**GENOA CHARTER TOWNSHIP BOARD**  
**Regular Meeting**  
**May 7, 2018**  
**6:30 p.m.**

**Re: Family Farm and Home Site Plan Review #5**

<b>Attention:</b>	Kelly Van Marter, AICP Planning Director and Assistant Township Manager
<b>Subject:</b>	Family Farm and Home – Special Land Use and Site Plan Review #4
<b>Location:</b>	3685 East Grand River Avenue – north side of Grand River, west of S. Latson Road
<b>Zoning:</b>	RCD Regional Commercial District

**SITE PLAN**

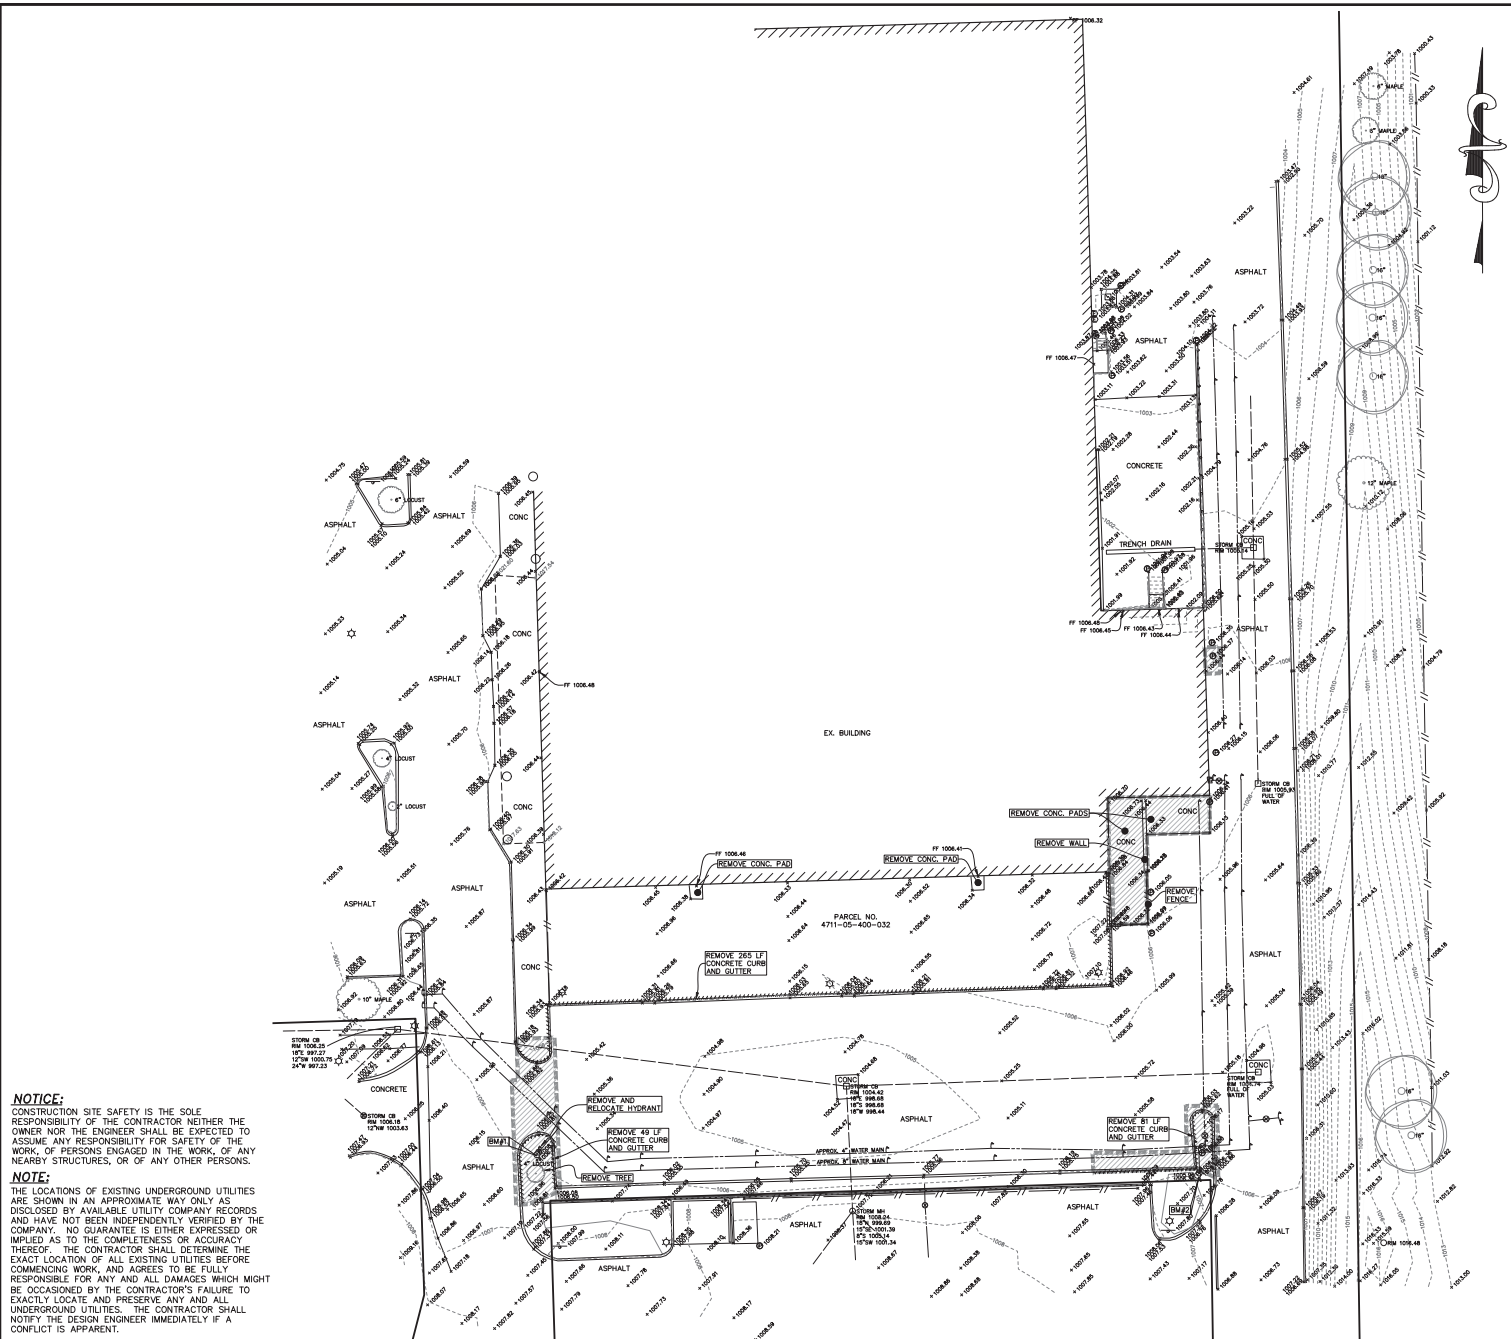
1. The area proposed for trailer storage should not be striped as shown on the site plan. Striping this area may confuse motorists of the intent of this area.

2. We suggest a protective bollard be placed on the end of the fence section of the trailer storage area to protect the fence from traffic.
3. A note should be added to the demolition plans to remove the existing tee for the hydrant being relocated and replace with a cutting in sleeve.

Since our comments are fairly minor we would support approving the special use site plan with the condition that the petitioner will address the comments above prior to a land use permit being issued.
